February 17, 2017

**ADDENDUM #2
8TH STREET ROAD IMPROVEMENT PROJECT
CITY OF CHATTANOOGA CONTRACT # T-16-014-201**

DATE: 01/13/17

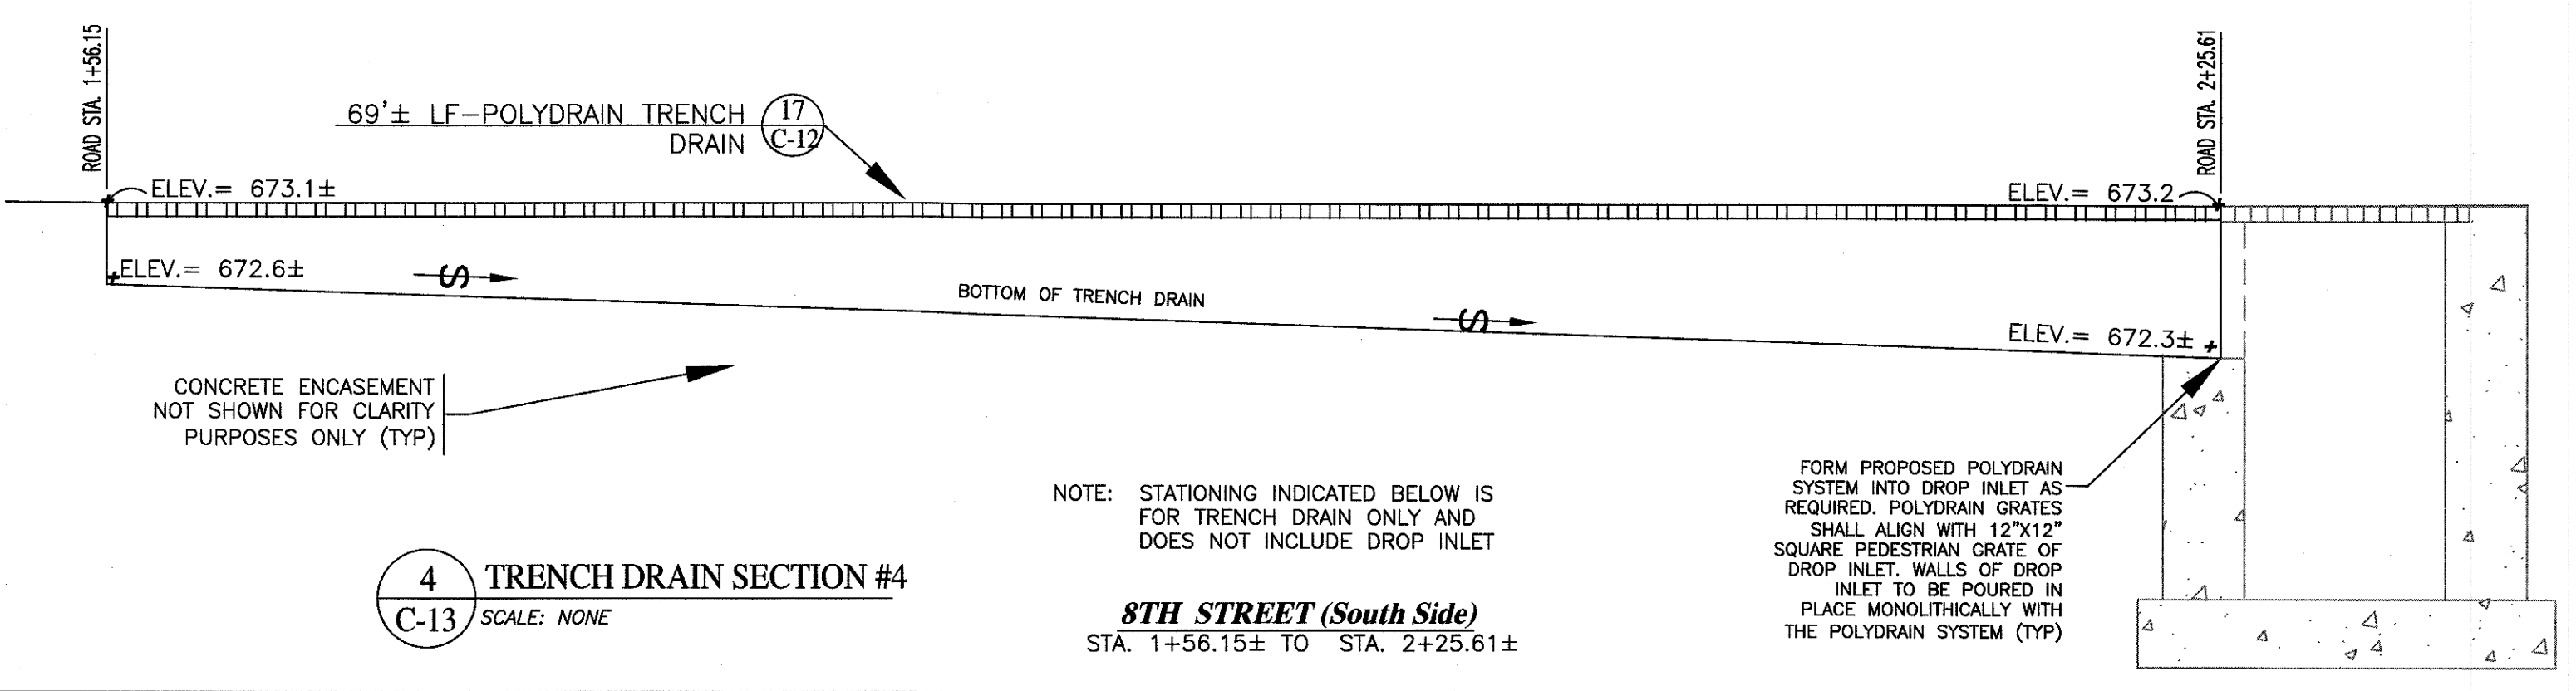
- Item #5.** Clarification: A full-depth asphalt pavement section was reflected on Sheet C-13 as part of Addendum #1. Finished grade elevations and/or storm drainage installation may require full-depth paving. Limits of full-depth pavement shall be determined in the field by contractor and

Item #18. Replace Sheet C-13 – Site Details (Originally dated 01/13/17) – with attached Sheet C-13 – Site Details (Revision #2 dated 02/16/17). Note the revisions consist of:

- Amending Detail #9 to reflect the full-depth pavement section of 8/2.5/1.5 as indicated.

confirmed by the Engineer. Please see the enclosed revised bid schedule to reflect the revised unit price line item for full-depth pavement specification.

SHEET NUMBER: L-1

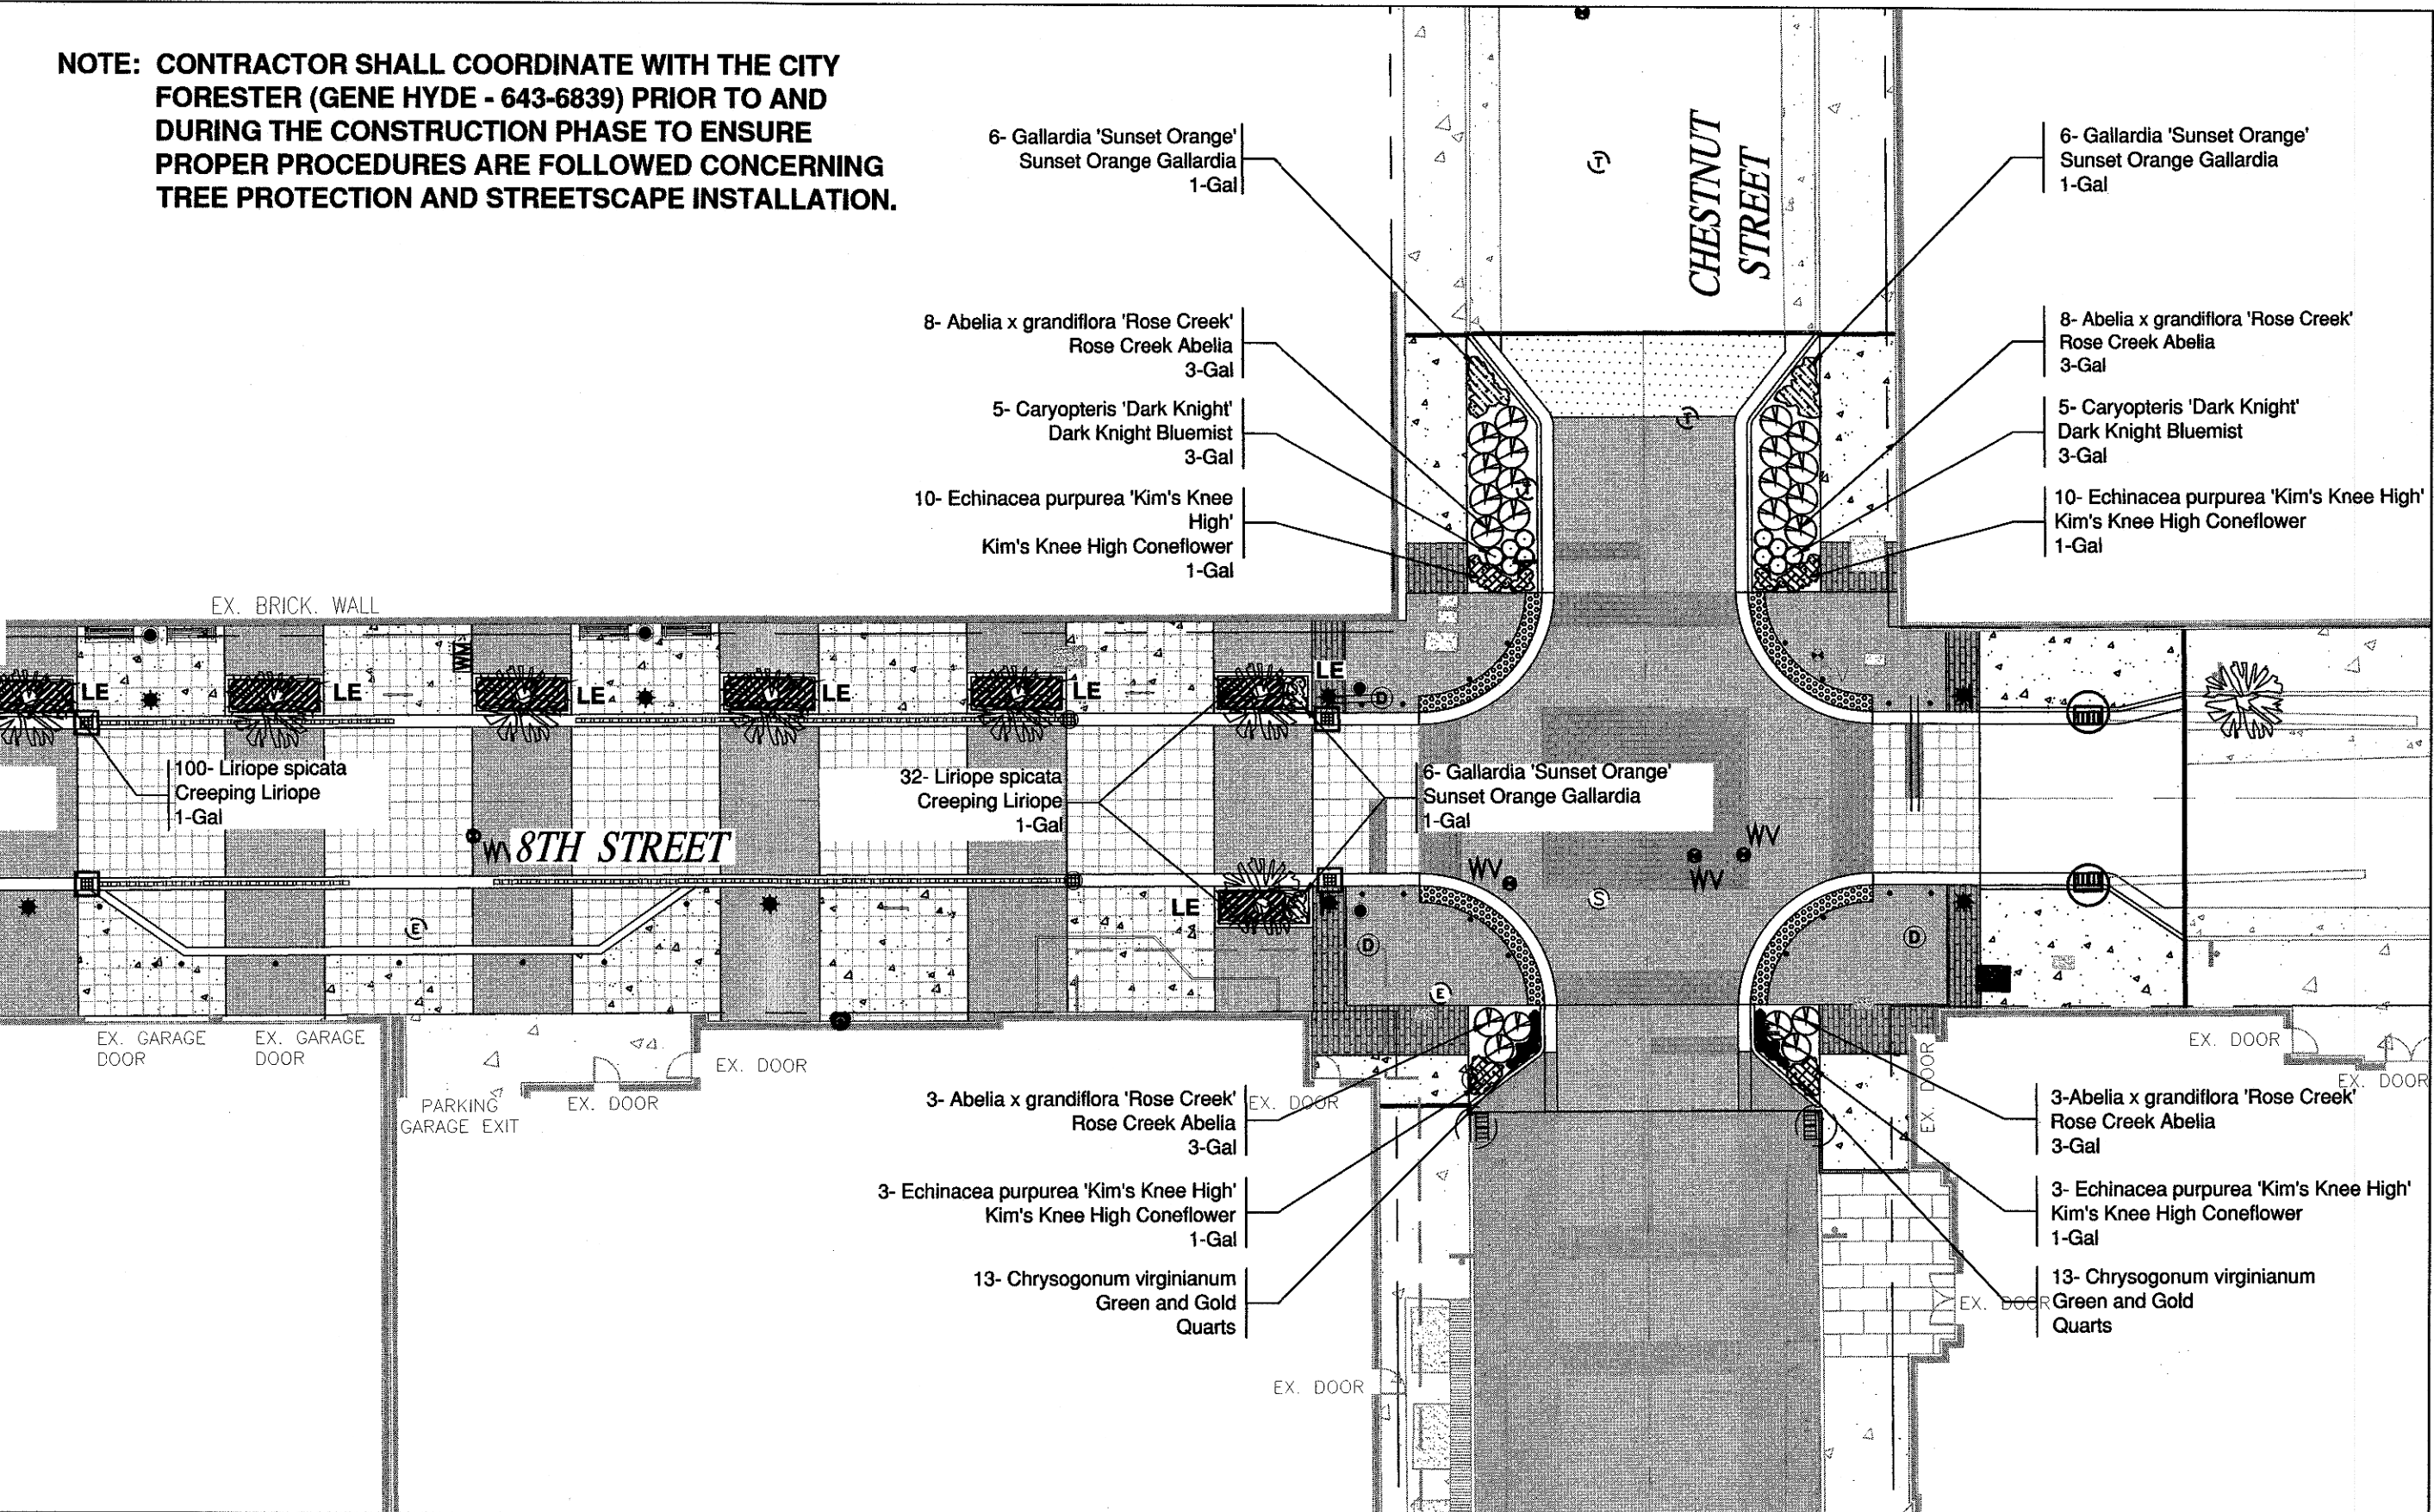
Item #19. Replace Sheet L-1 – Landscape Plan (Originally dated 01/13/17) – with attached Sheet L-1 – Landscape Plan (Revision #1 dated 02/16/17). Note the revisions consist of:

- Adding ground-level plantings to the tree wells along 8th Street and the planter beds on the north/south portions of the 8th/Pine Street Intersection. (Note: Plantings along Pine Street portion shall be completed by the Pine Street contractor and shall not be included in pricing for 8th Street work).
